McKeon Park

Town of Barnstable ADA Transition Plan

Institute for Human Centered Design

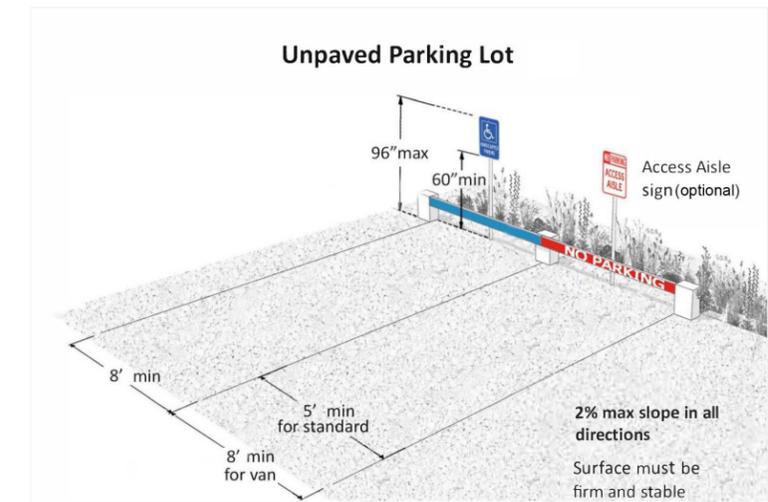
The following illustration shows one way to mark accessible parking spaces at unpaved parking areas.
